NEWMAR CORPORATION WARRANTY DEPARTMENT

TECHNICAL SERVICE BULLETIN							
DATE ISSUED	MODEL YEAR(S) AFFECTED	MODEL(S) AFFECTED	TSB #				
10/9/92	1993	ALL	65				
BRAND		TYPE					
All <input checked="" type="checkbox"/>	American Star <input type="checkbox"/>	Kountry Star <input type="checkbox"/>	Dutch Star <input type="checkbox"/>	All <input checked="" type="checkbox"/>	T T <input type="checkbox"/>	F W <input type="checkbox"/>	
NewAire <input type="checkbox"/>	Mountain Aire <input type="checkbox"/>	Kountry Aire <input type="checkbox"/>	London Aire <input type="checkbox"/>	C A <input type="checkbox"/>	D P <input type="checkbox"/>	D B <input type="checkbox"/>	
<input type="checkbox"/> Air Conditioning & Heating				<input checked="" type="checkbox"/> Electrical Components			
<input type="checkbox"/> Appliances & Accessories				<input type="checkbox"/> Exterior Components			
<input type="checkbox"/> Cabinets & Furniture				<input type="checkbox"/> Interior Components

NEWMAR CORP. SLIDE-OUT SWITCH WIRING PROCEDURE

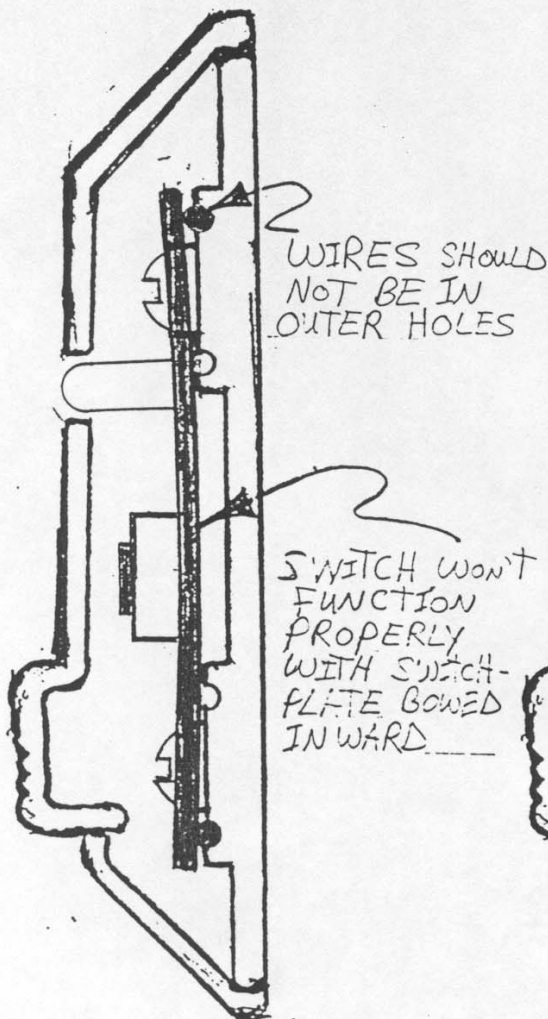
<input type="checkbox"/> Chassis Components				<input type="checkbox"/> Plumbing & Bath Components			
<input type="checkbox"/> Construction Components				<input type="checkbox"/> Windows, Awnings, Vents, & Doors			
DESCRIPTION OF PROBLEM							
Slide out switch is not operating correctly due to not being wired right.							
RECOMMENDED SOLUTION							
Slide out switch wires must be changed per slide view print enclosed.
